DEPARTMENT OF TRANSPORTATION**DISTRICT 6**

06-TUL-63-5.45

06-TUL-63-5.45
RESPONSE TO COMMENTS ON TIA
VISALIA PARKWAY DEVELOPMENT (7)

SITE PLAN NO.: 19-055 2ND RESUBMITTAL
PROJECT TITLE: VISALIA PARKWAY
DESCRIPTION: PROPOSED SHOPPING CENTER DEVELOPMENT
APPLICANT: DANIEL ZOLDAK
PROP OWNER: VISCA INVESTMENT CO
LOCATION: SWC VISALIA PARKWAY & MOONEY BLVD
APN: 128-960-001

Susan Currier – TSM for SPR 19055
August 29, 2019
Page 2

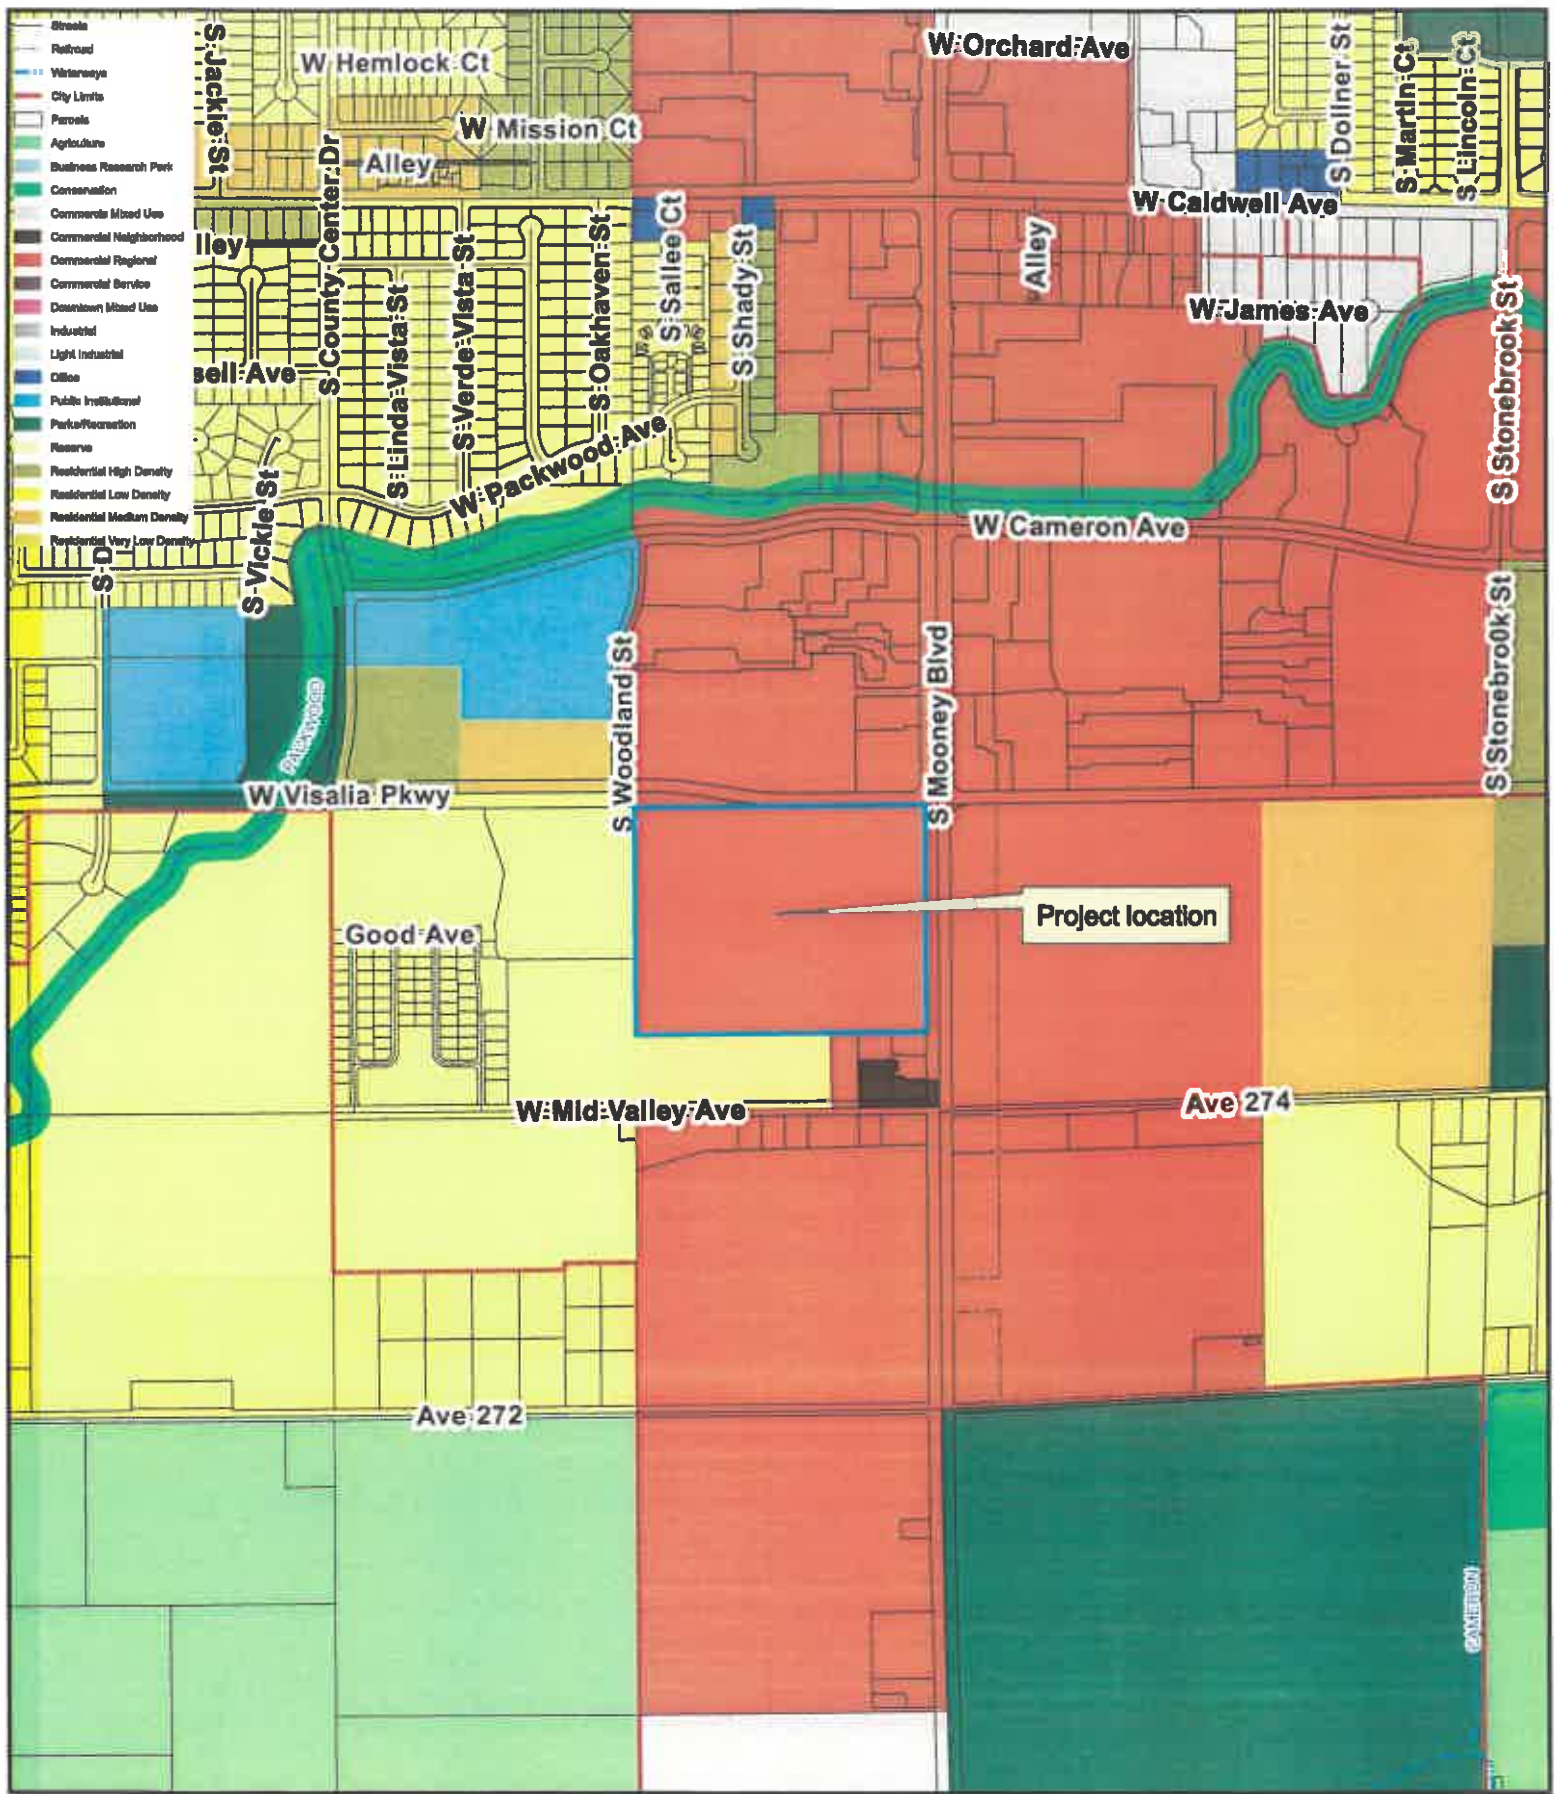
5. The Tentative Subdivision Map *shows only* 11.50 feet offered for dedication to Caltrans along SR 63. The TSM does not provide measurements for the roadway width.
6. Please revise the Tentative Subdivision Map to indicate the existing right-of-way of 55 feet from the centerline and the *required* 23 feet of dedication to accommodate opening day improvements and the planned configuration of SR 63.
